SUBJECT: Forwards Revision 1 to "Procedures for Soil Backfill Testing Program" and provides info. re Quality Class II backfill program purposes & scope, in response to NRC request for additional info made during 811007 meeting. Boring location plan encl.

## Washington Public Power Supply System

November 12, 1981  
G02-81-462

Subject: SUPPLY SYSTEM NUCLEAR PROJECT NO. 2  
QUALITY CLASS I SOIL BACKFILL TEST PROGRAM

FIGURE 1 -  
BORING  
LOCATION  
PLAN

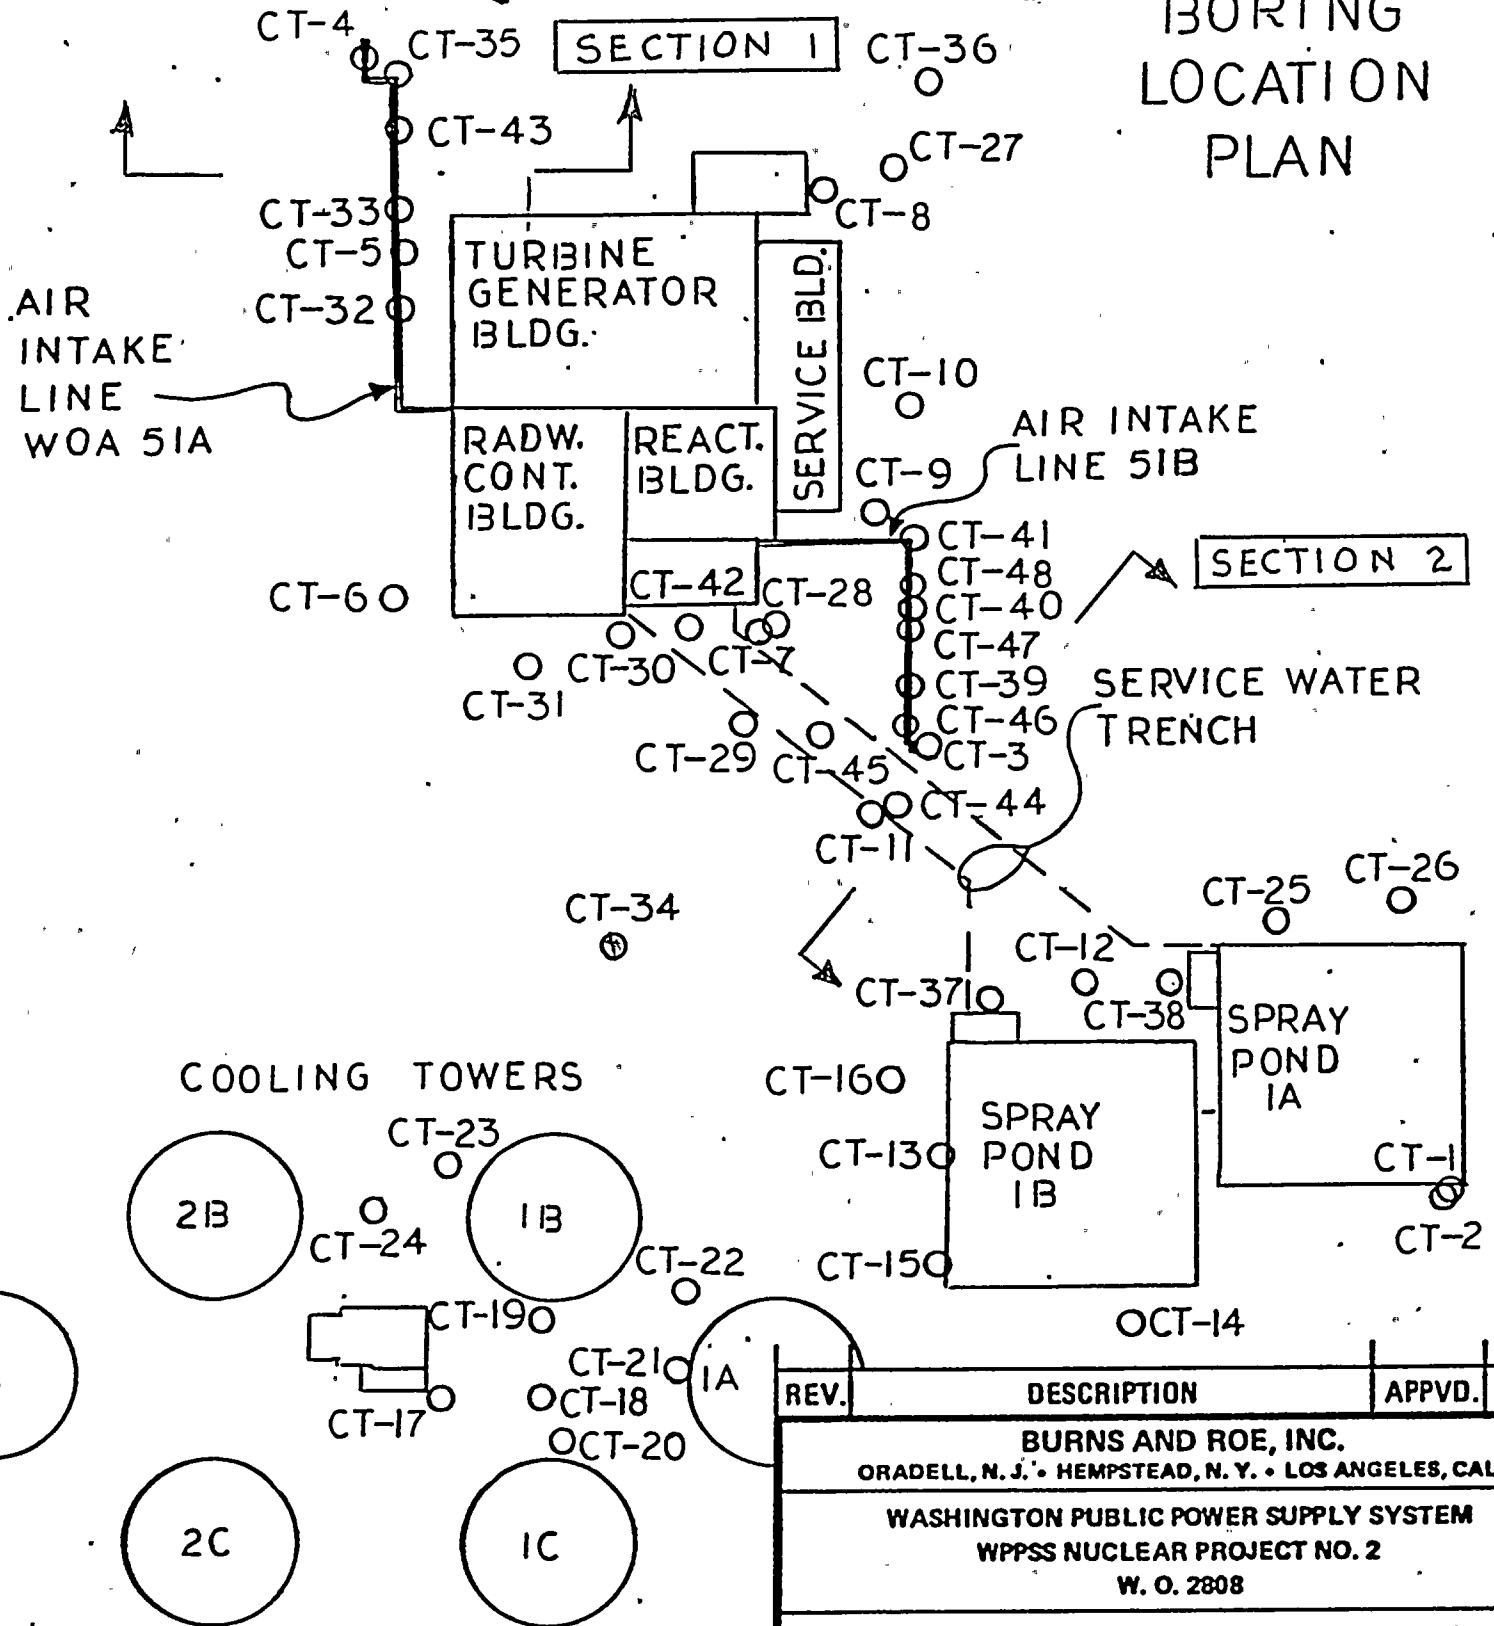
1. "Extent of areas and depth of backfill in areas of concern as identified by 10CFR50.55(e) Condition No. 146"?

3. "Proposed types of tests, number, and location of tests"?

The horizontal extent of these areas in relation to other plant components are shown on the accompanying Boring Location Plan, Figure 1. Except as described below, the lowest extent of any of the backfill for these safety related systems is elevation 430 feet. The maximum rise in ground water that may occur if the Ben Franklin Dam is constructed is 420 feet, above which liquefaction is not a problem. However, some of the backfill placed under these systems was to a minimum elevation of 413 feet where the Class II circulating water and storm sewer systems cross under the safety related utility. (See section 3.1.12 of the "Procedure for Soil Backfill Testing Program", attached, for discussion of boring depth).

The boring location plan shown in Figure 1 shows the location of the various test sites. Table 1 shows the number and types of tests taken at various depth intervals for each boring in the areas of concern (i.e. safety related backfill placed since May 1976). A detailed description of the type of tests can be found in the attached "Procedure for Soil Backfill Testing".
